**COUNTY OF MIDDLESEX - INTERROGATORY #1**

Filed: May 23, 2013  
EB-2013-0040 and EB-2013-0041  
Exhibit B  
Tab 1  
Schedule 3  
Responses to County of  
Middlesex Interrogatories  
Appendix A

AREA	SUBJECT
1001 115kV TRANSMISSION LINE	STEEL POLE DESIGN PLAN & PROFILE DRAWINGS SHEET 1 OF 12
CLIENT DWG. NO.	REV.
DRAWING NO. 1235-2-P012-S1	G

STEEL POLE DESIGN  
PLAN & PROFILE DRAWINGS  
SHEET 5 OF 12

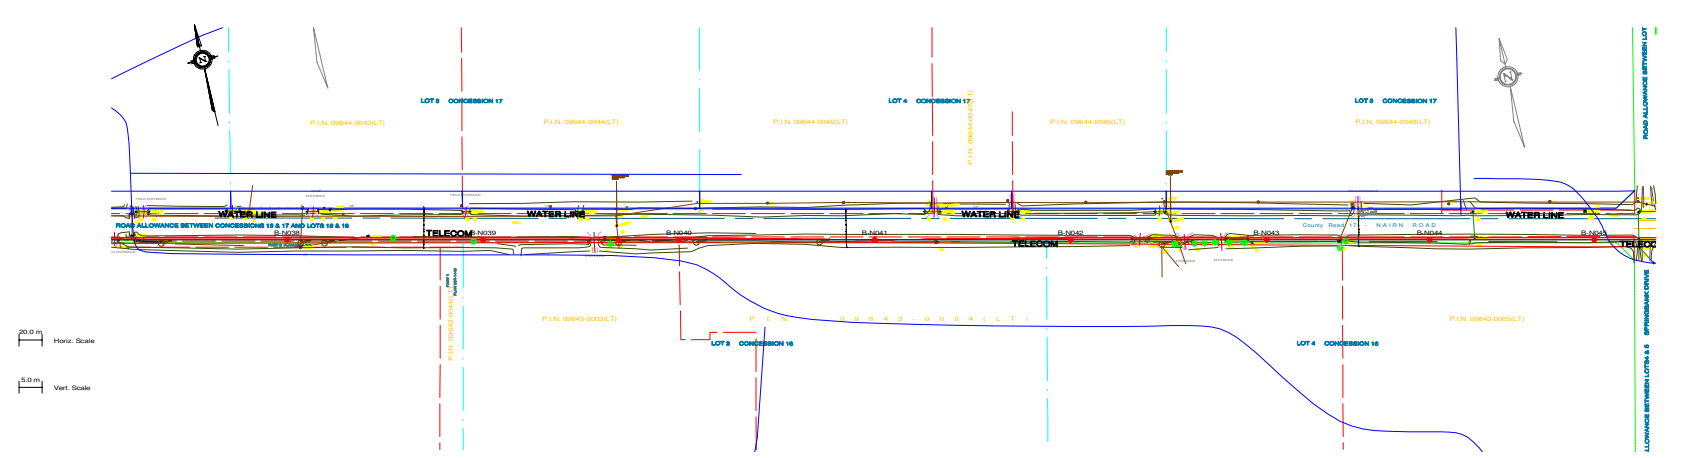
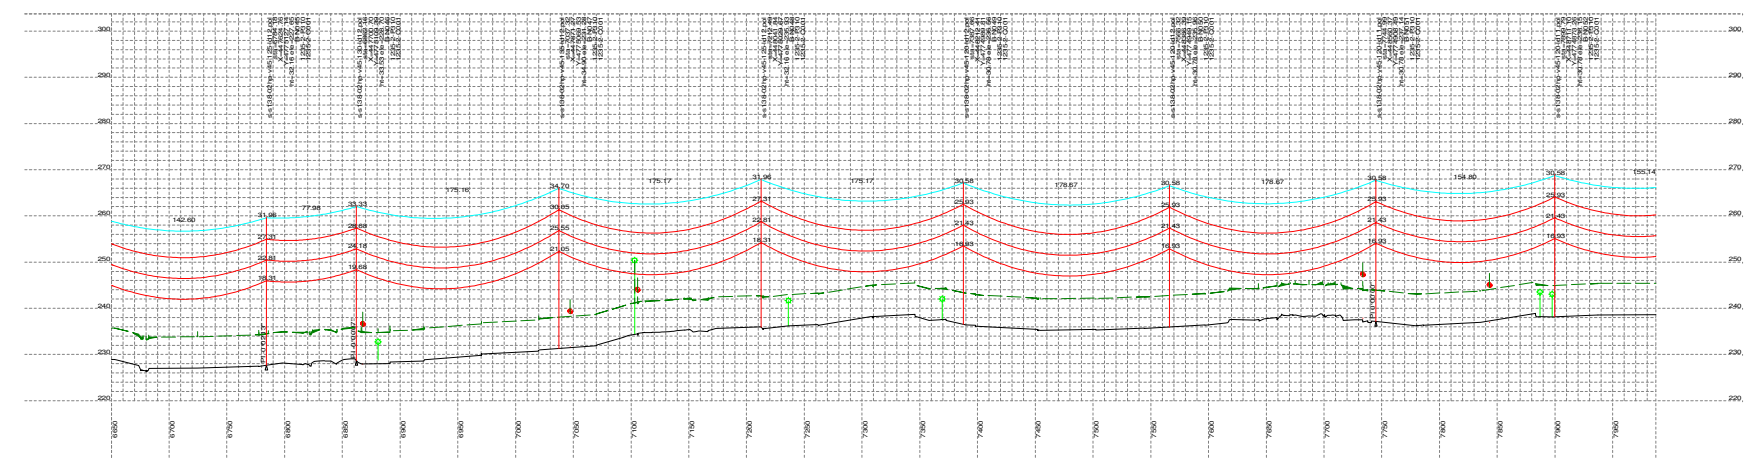
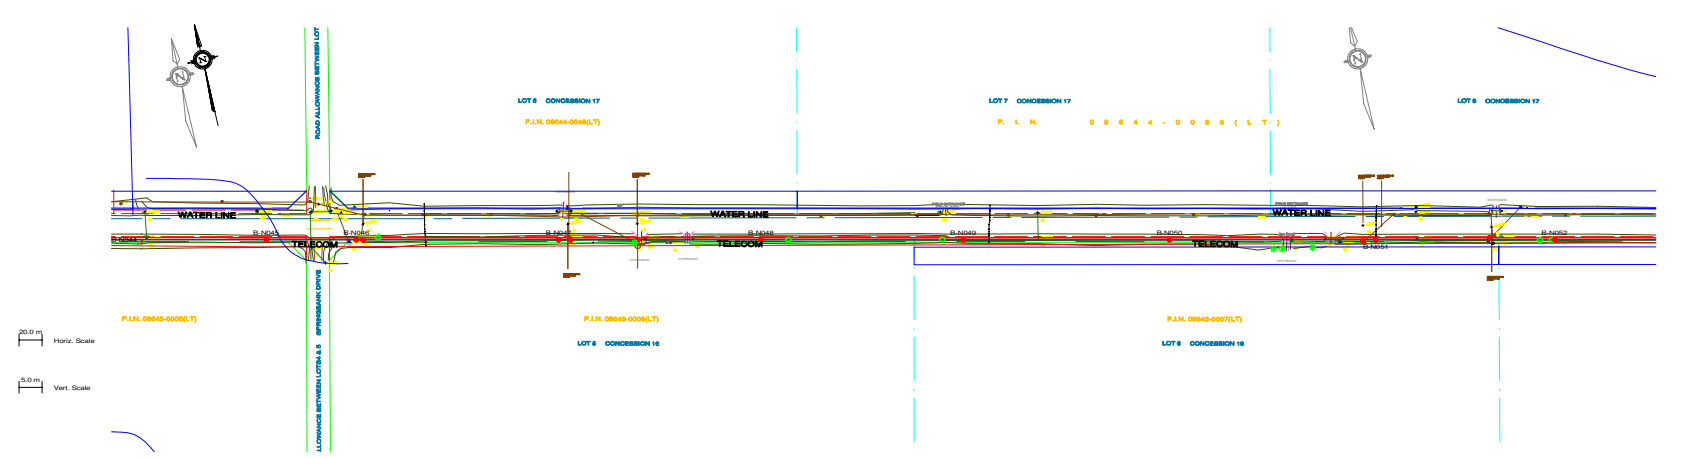
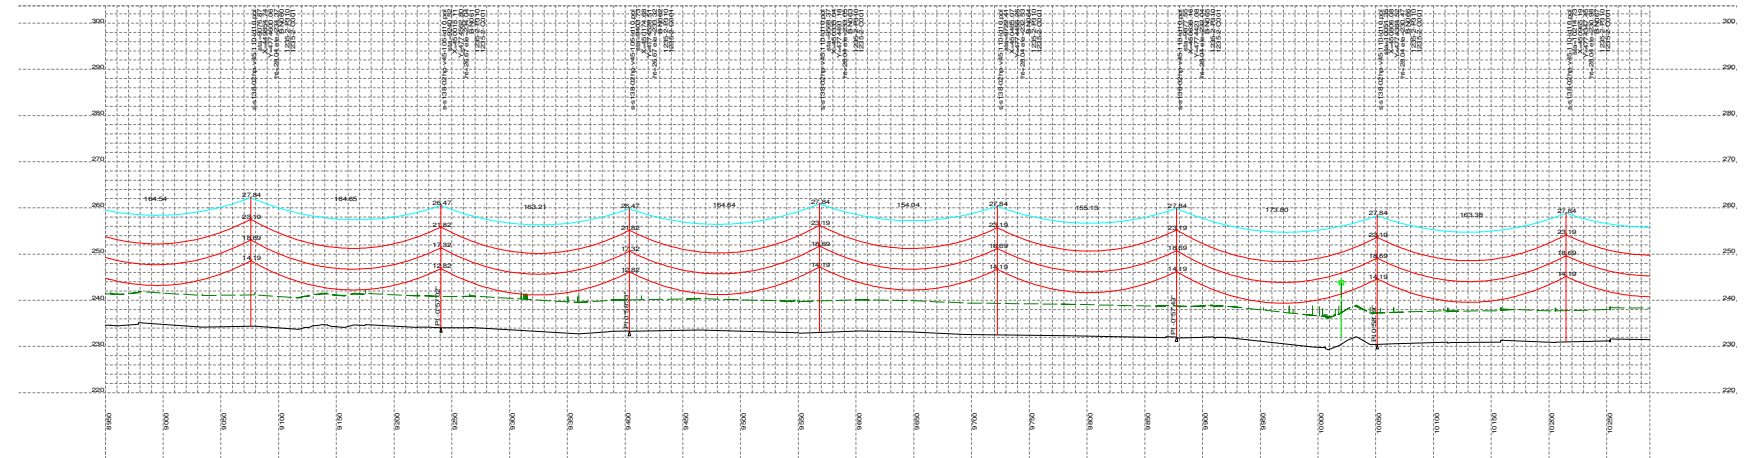
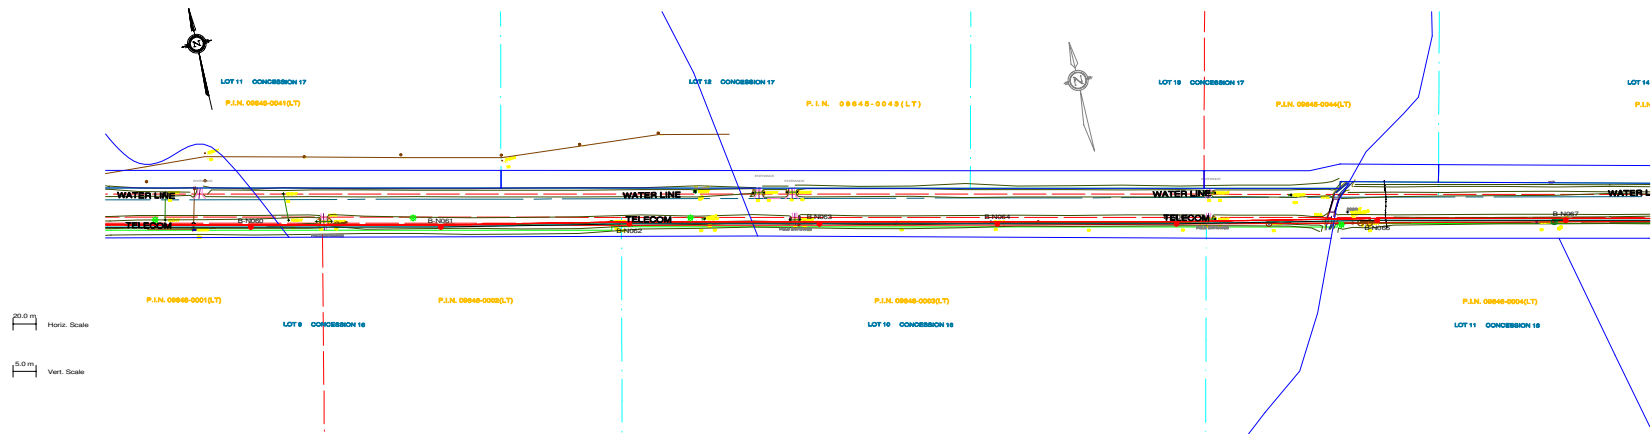
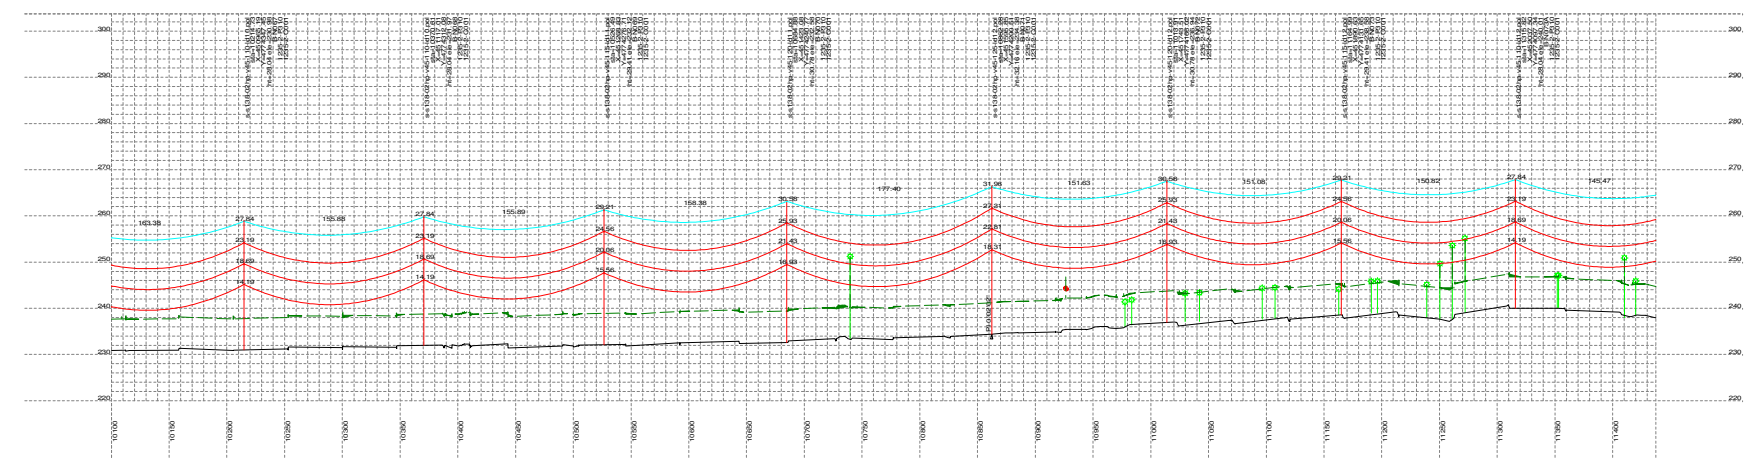
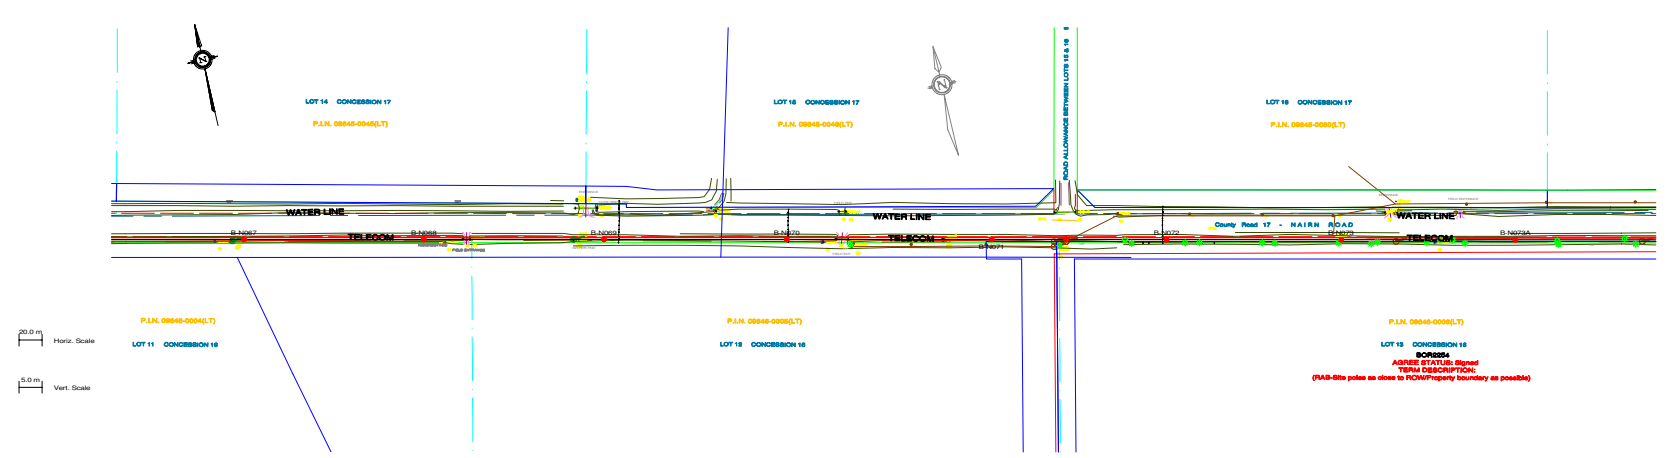
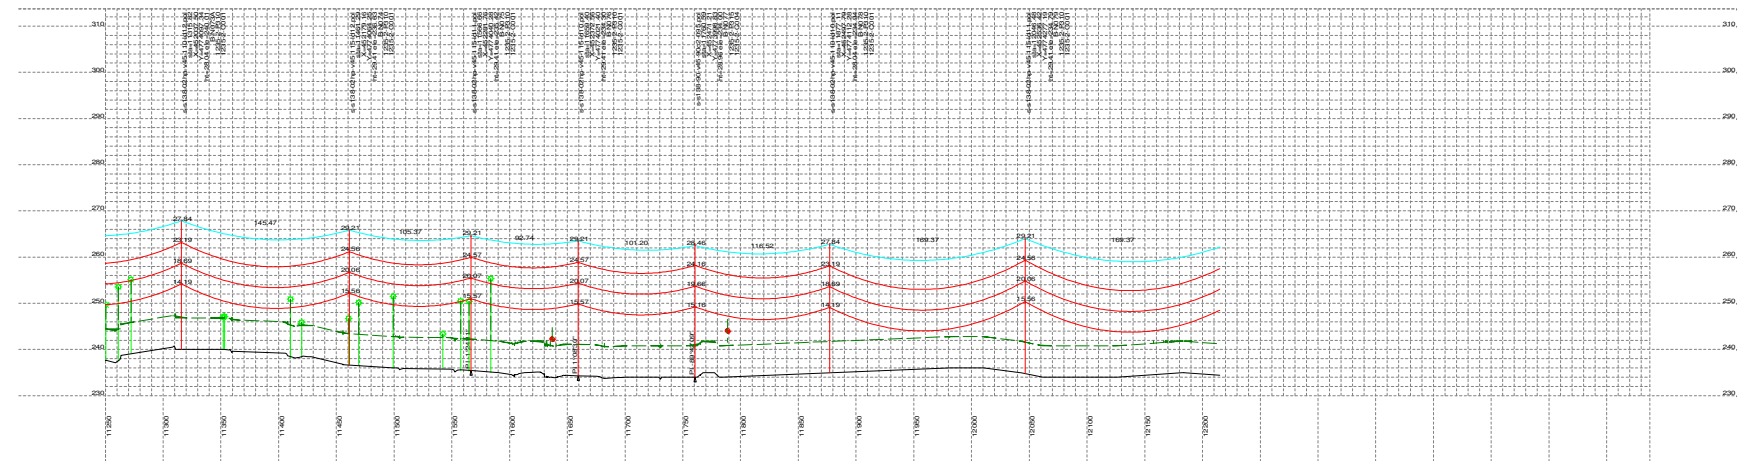
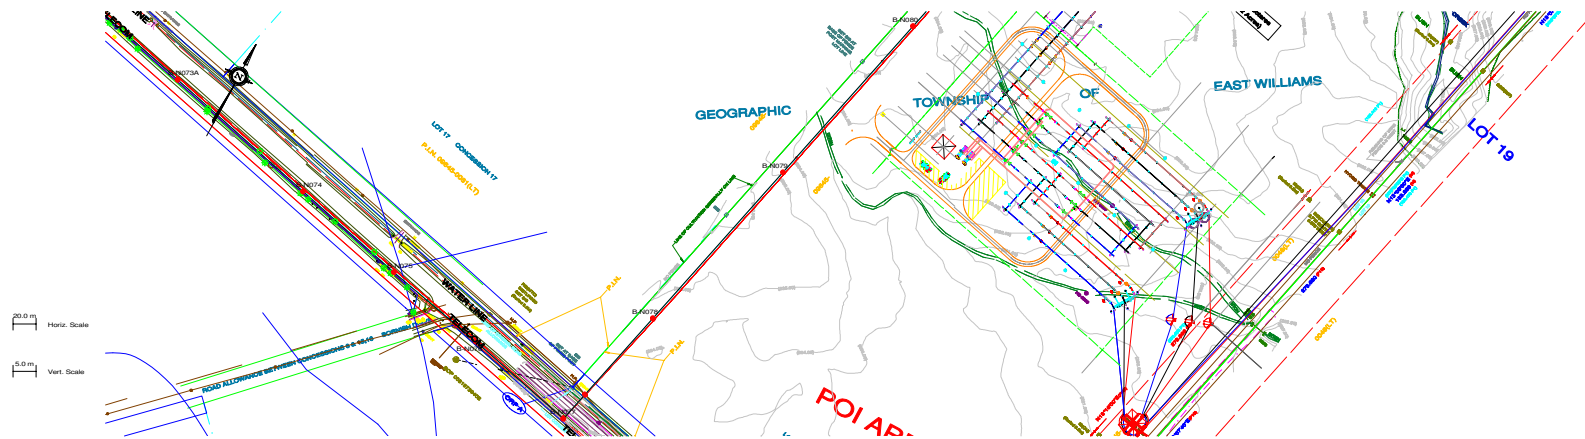
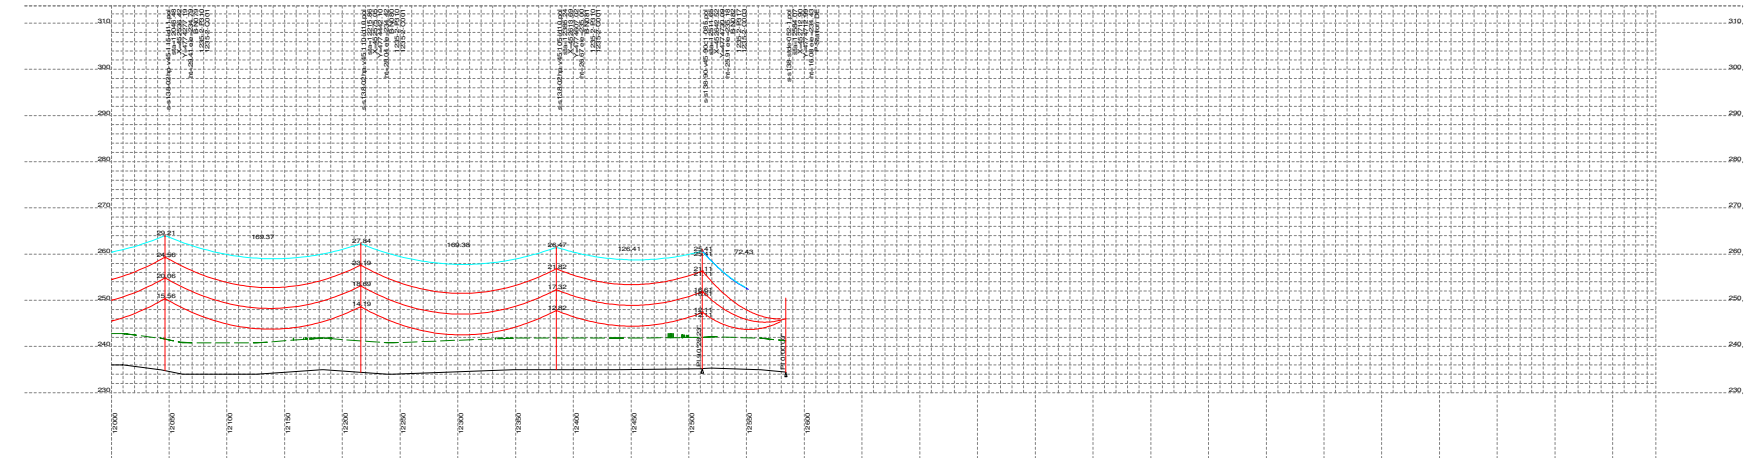
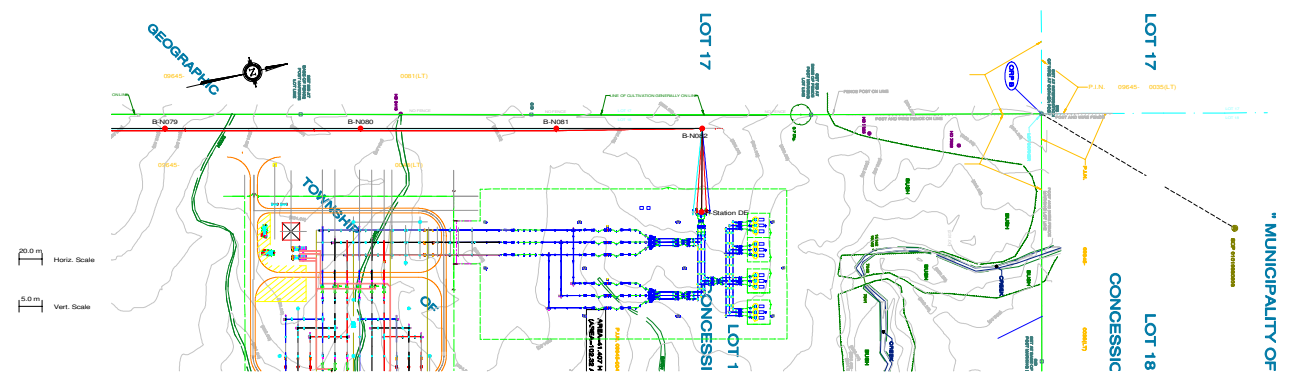
Please provide detailed engineering drawings showing the exact location of all poles and other appurtenances proposed to be located within County road allowances for transmission lines, including all material and construction specifications of poles, wires, guying, foundations, trenching, temporary conditions, and any other items related to this infrastructure.

Please see profile drawings in **Appendix 'A'** in respect of EB-2013-0040 and **Appendix 'B'** in respect of EB-2013-0041 depicting the current design, which is subject to final engineering. Earlier versions of these sets of drawings were provided to the County's Engineer on November 12, 2012. These drawings show the proposed pole, wire and anchor locations. Plans with respect to foundations, materials and construction specifications are not yet finalized. The physical design specifications for the proposed transmission line, including with respect to potential materials, are described in Exhibit D, Tab 1, Schedule 1. In addition, illustrations of potential pole structures and framing designs are provided in Figure 4 of Exhibit B, Tab 2, Schedule 5.
